Title **Relaying RNG-REQ/RSP for MS Network Entry**

Date Submitted **2007-03-05**

Re: Call for technical proposals regarding IEEE project P802.16j

Abstract This contribution proposes the scheme with which RS supports MS scanning operation.

Figure <XXX>03—Ranging and automatic adjustments procedure in MR mode

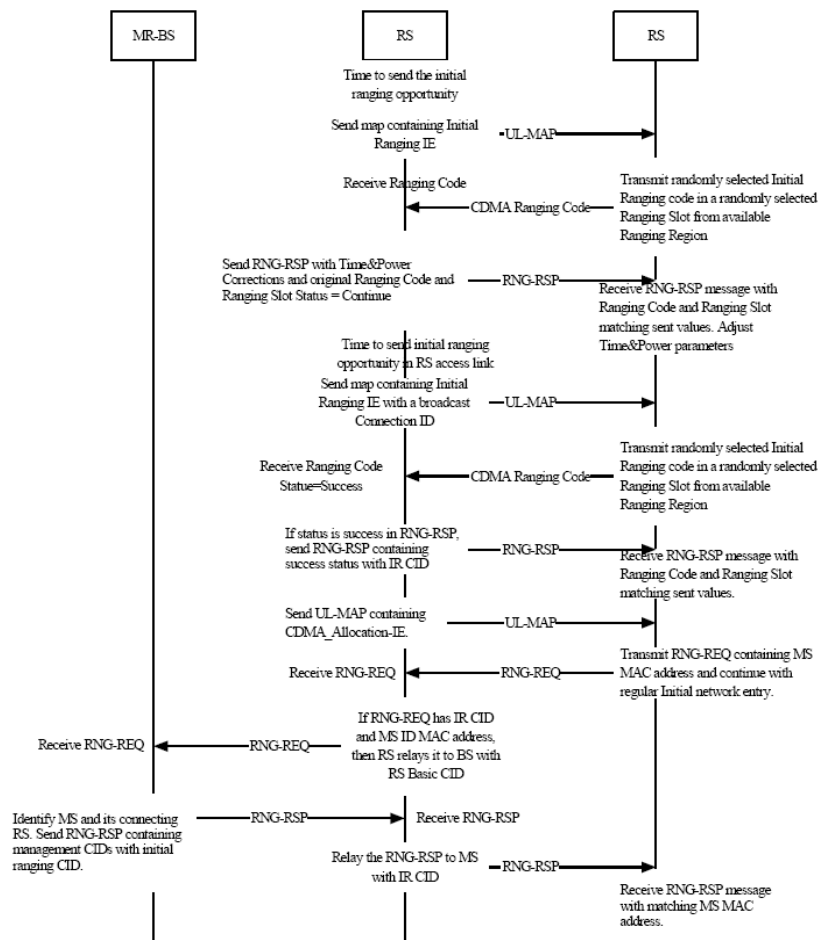
In IEEE 802.16j Baseline document 06/026r2, the initial ranging process in Non-transparent RS with Distributed scheduling as defined at section 6.3.9.16.2.2 as described in the figure <XXX>03.

However, when a RS relays RNG-REQ and RNG-RSP between MS and MR-BS, some field in the message is appropriate to be responded by the RS. For example, the Downlink Operational Burst Profile for a MS in RNG-RSP should be responded by the RS since the RS is the actual node which is physically communicating with the MS.

"Receiving the RNG-REQ containing the MS MAC Address, the RS may decide which TLV is managed by itself in the RNG-RSP. If there is any field to be managed by the RS such as Downlink Operational Burst Profile, the RS omit the TLV from the RNG-REQ and recompose the RNG-REQ message. The RS transmit the RNG-REQ message ~~relays it~~ with the RS basic CID instead of IR CID in the header to MR-BS.

Once the MR-BS receives the RNG-REQ containing MS MAC Address with the RS basic CID, the MR-BS shall assign Basic and Primary management CIDs to the MS, and transmit a RNG-RSP containing those management CIDs and MS MAC Address with the RS basic CID.

The RS receiving the RNG-RSP containing the management CIDs and MS MAC Address may add the TLV field which is managed by RS and shall transmit~~relay~~ it to the MS with the initial ranging CID..."
